BGA RESPONSE TO THE RAF BRIZE NORTON ACP CONSULTATION

The GAA Alliance Response (as previously submitted)

Annex A - Proposed airspace design for LOA and RAF Brize Norton

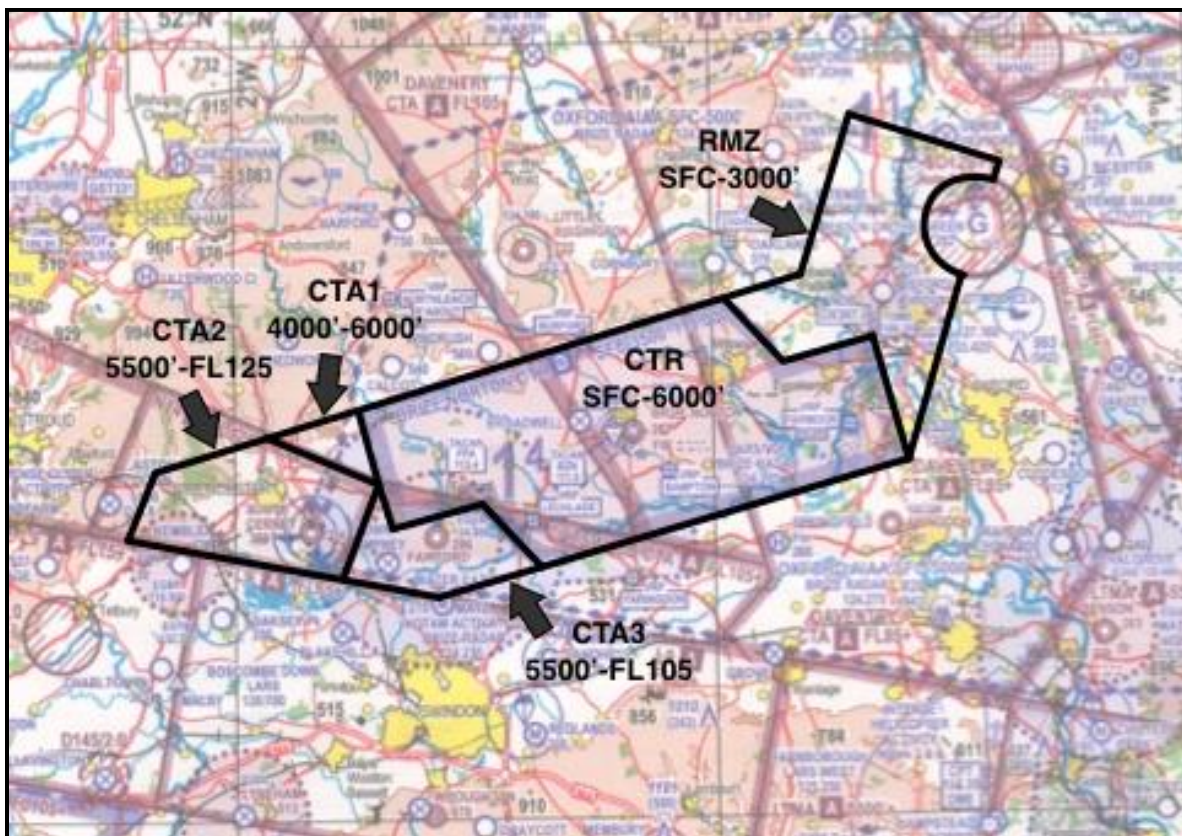
14. Considers together with LOA the alternative airspace design we propose at Annex A which, in conjunction with the adoption of the above recommendations, will help achieve the sponsor's objectives, but with significantly less additional Class D airspace. Procedure design work has been undertaken to ensure it is possible to achieve this reduction and we would welcome more detailed discussion with the sponsor to ensure it is compatible with their operational requirements.

Notwithstanding our fundamental concerns about the consultation process and the substance of the consultation document, we believe it should be possible, through better engagement, to meet the needs of both the sponsor and other aviation stakeholders within extant controlled airspace lateral boundaries by:

- Enhancing the RAF Brize Norton radar facility and revising ATC and operational procedures to enhance track-keeping within the present zone;
- Raising the upper level of the present CTR and adding a small volume of additional airspace to link with Airway L9;
- Implementing enhanced coordination and control of RAF Brize Norton traffic to and from Airway L9;
- Implementing enhanced coordination with LOA;
- Mitigating overall risk to ALARP for all airspace users.
